Staff Report

To: Salt Lake City Planning Commission
From: Cassie Younger, Senior Planner, cassie.younger@slc.gov
Date: September 23, 2026
Re: PLNPCM2026-00539

Design Review

PROPERTY ADDRESS: 950 W 1000 N
PARCEL ID: 08-26-258-014-0000
MASTER PLAN: Northwest Community, Rose Park Small Area Plan
ZONING DISTRICT: MU-2 Mixed Use 2 District
PROPERTY SIZE: .35 acres/ 15,246 square feet

A1 SITE & LEVEL 1 - PLAN

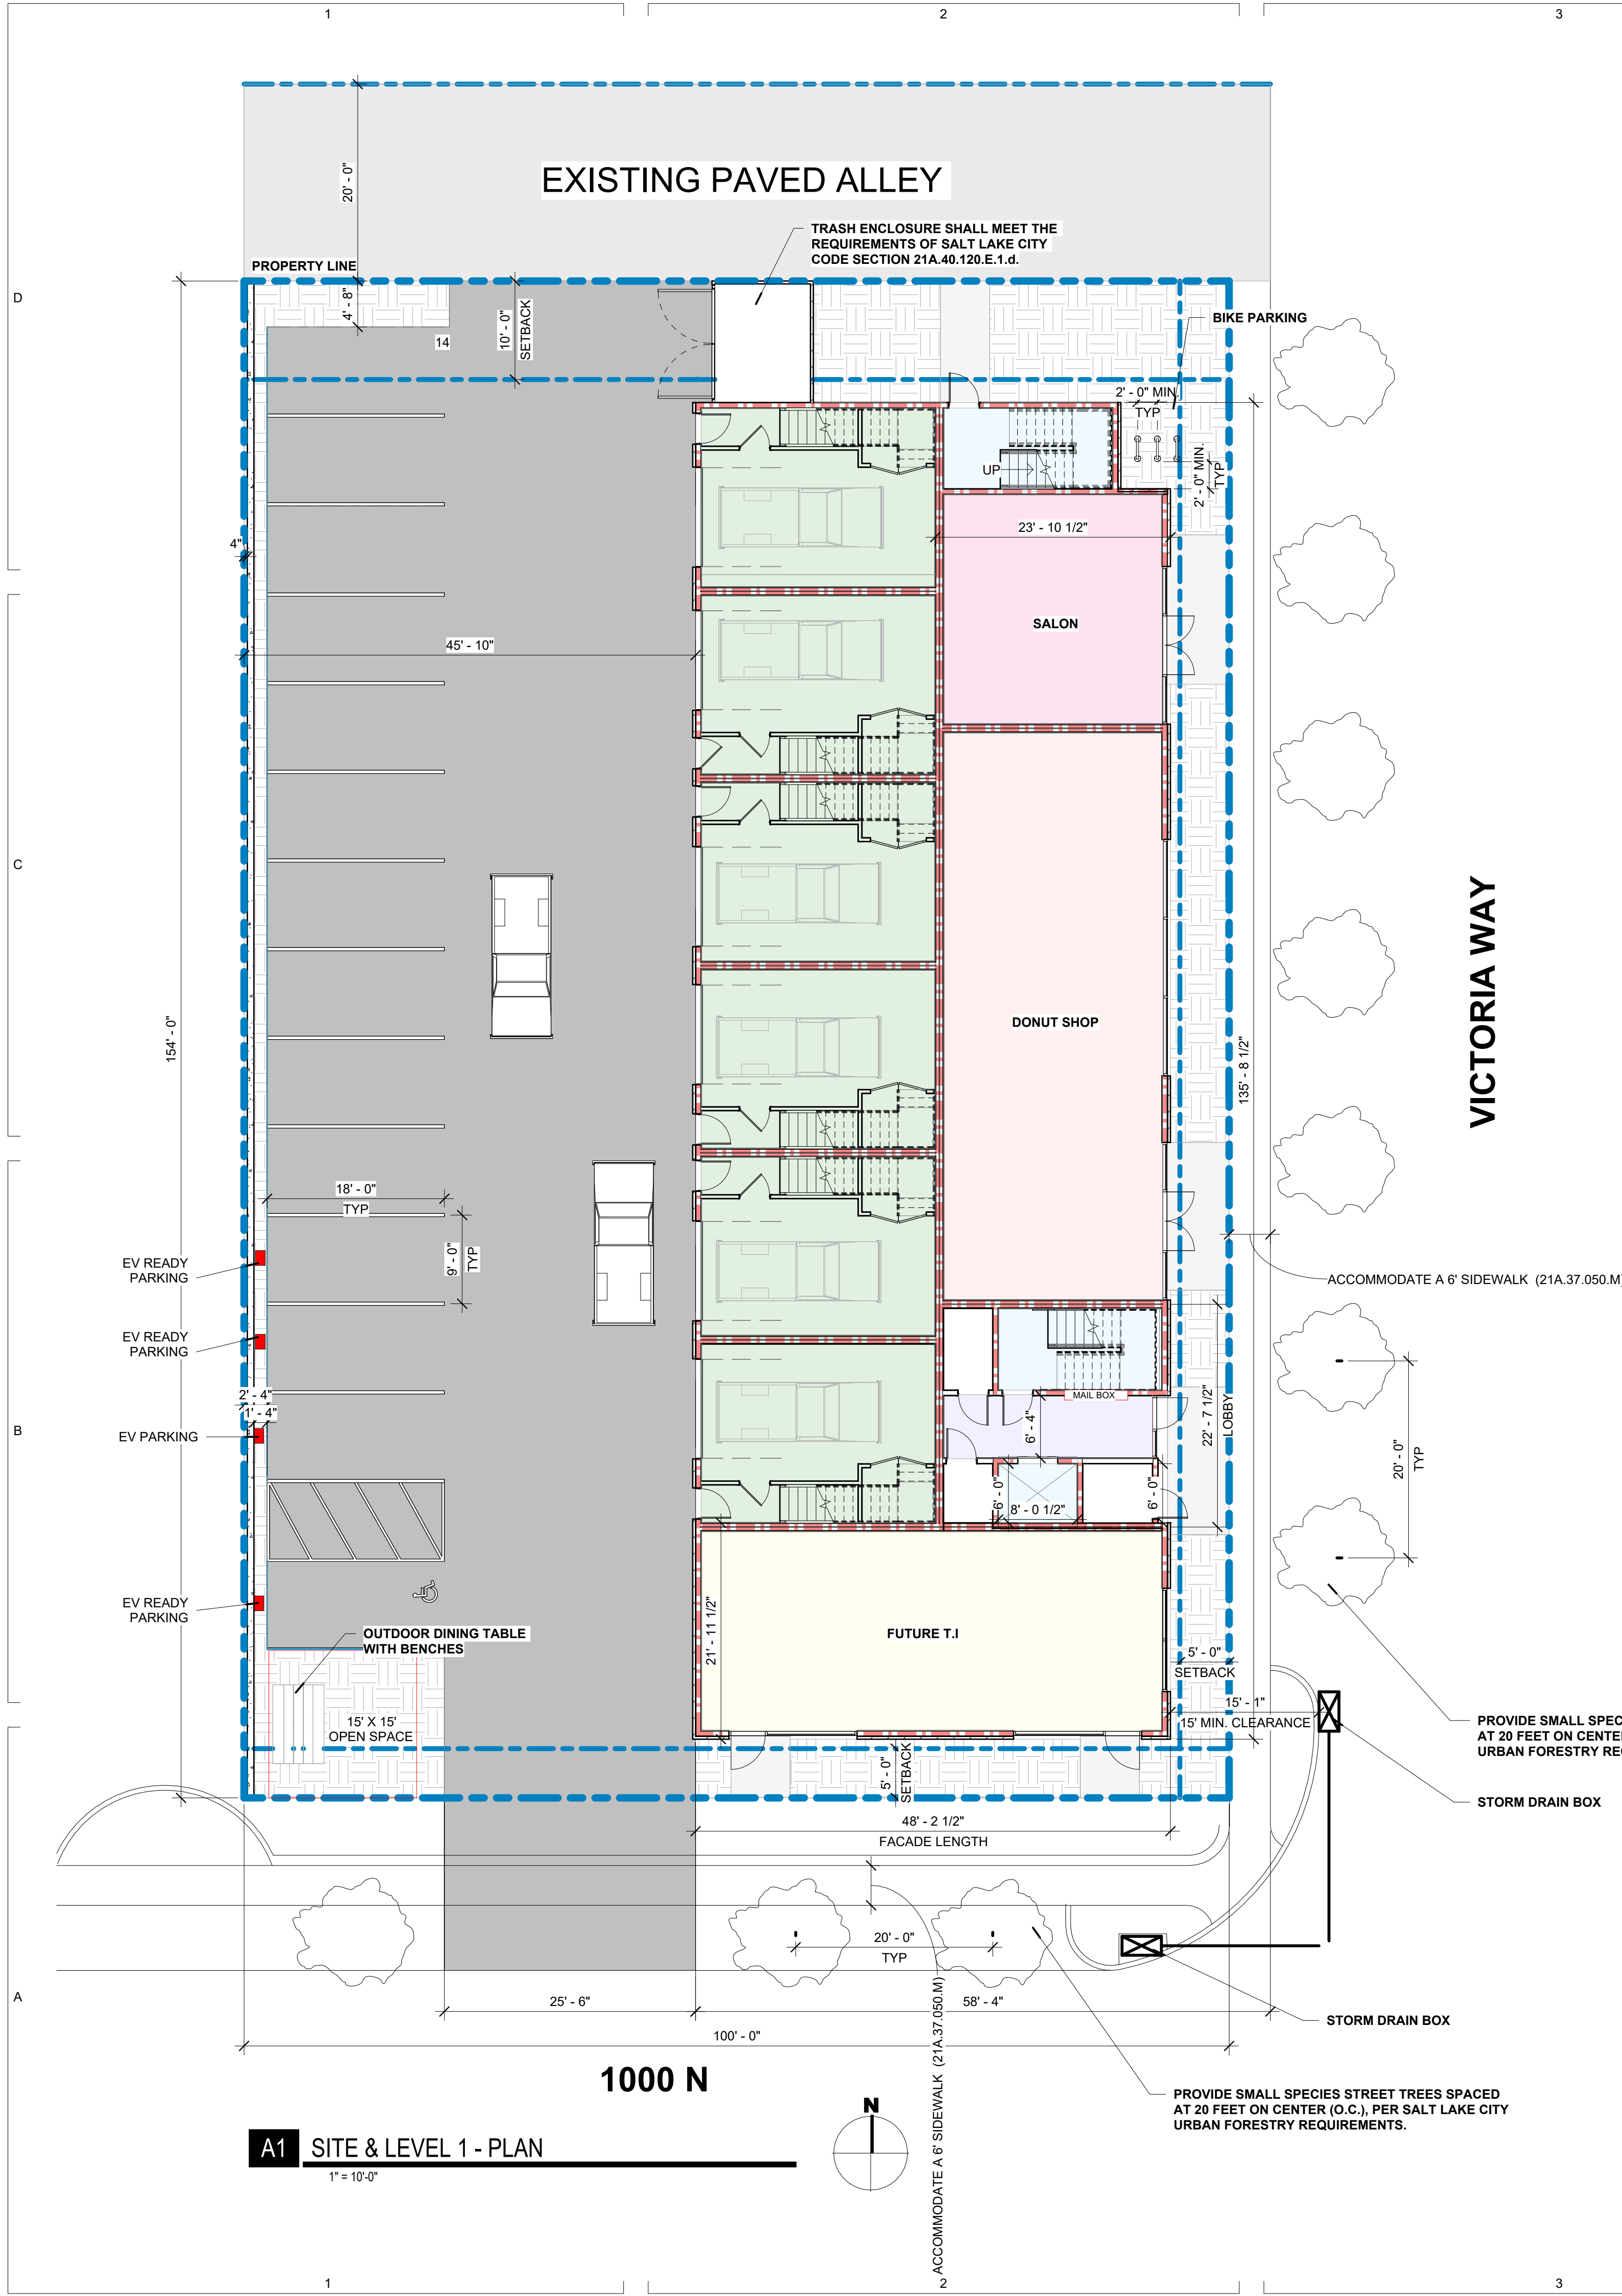
Designs standards require widening the existing 4' wide sidewalk to 6' (21A.37.050.M). Sidewalk must be widened toward the property to avoid narrowing the park strip. On 1000 North there is room between the existing sidewalk and the property line to add the additional 2' within the right-of-way. On Victoria way the widening will need to be done on the property. Transportation has no other issues with the proposal.

Development is required to relocate the public storm drain at the southeast corner of the property so that a minimum of 15 feet is provided between the public storm drain facility and the building. This will be required at the property owner's expense. A plan and profile and engineer's cost estimate must be submitted for review during the building permit process. Design drawings and cost estimate

Additionally, an easement will be required on the private property to provide SLCDPU access to this area between the public storm drain facility and the building (i.e. 15 feet from all public storm drain to the east and south of the property).

C1 ELEVATION - SOUTH

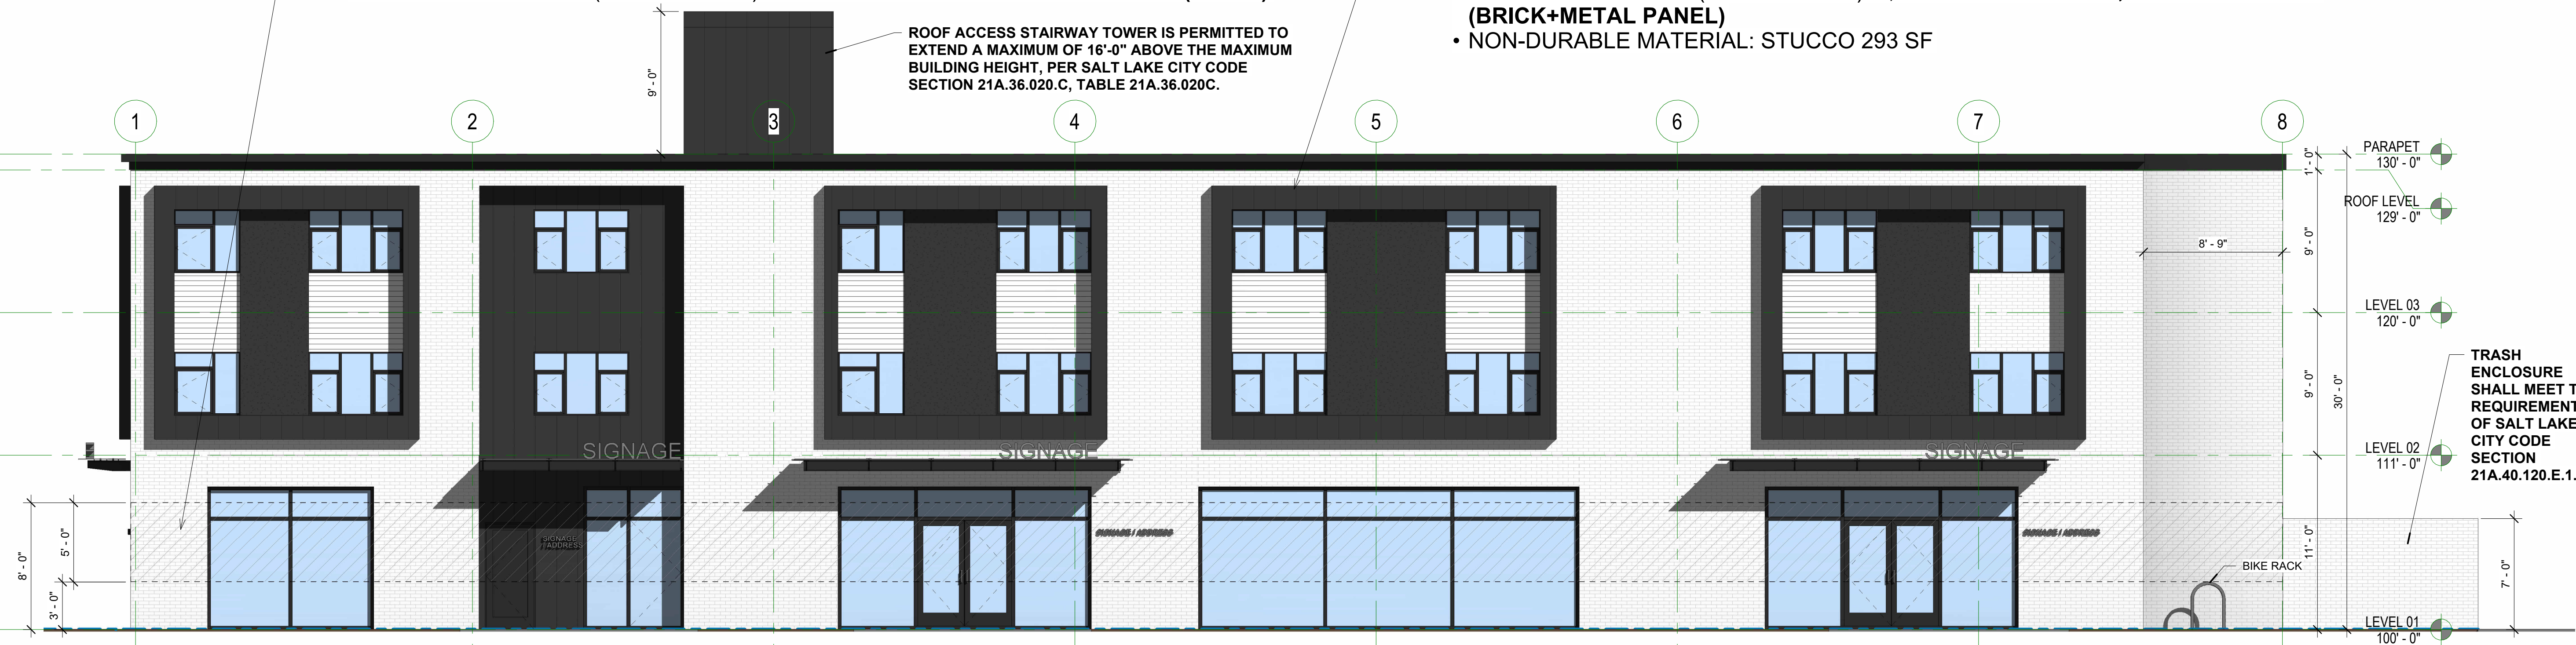
The façade length along Victoria Way consists of white brick, black and white metal paneling, and a small portion of black stucco. As outlined in Design Review Standard E, long facades should be designed to reduce the perceived length of the facade and provide visual interest.

The proposed design includes a series by a series of black metal paneling and stucco that frame residential windows on the upper floors, which helps to break up the building wall. The black metal paneling sections project from the wall plane approximately 1', which minimizes the appearance of a flat and uninterrupted wall. The awning provides accents the commercial entryways, while the residential entrance can be distinguished by a recessed entrance with black metal paneling that differs from the rest of the white brick along the ground floor façade. The last 8'9" of the façade is recessed 4', which further reduces the visual length of the building.

This series of plane changes, material changes, and a variety of entrances and ground floor windows, break up the façade to reduce monotony while remaining pedestrian friendly along the street frontage.
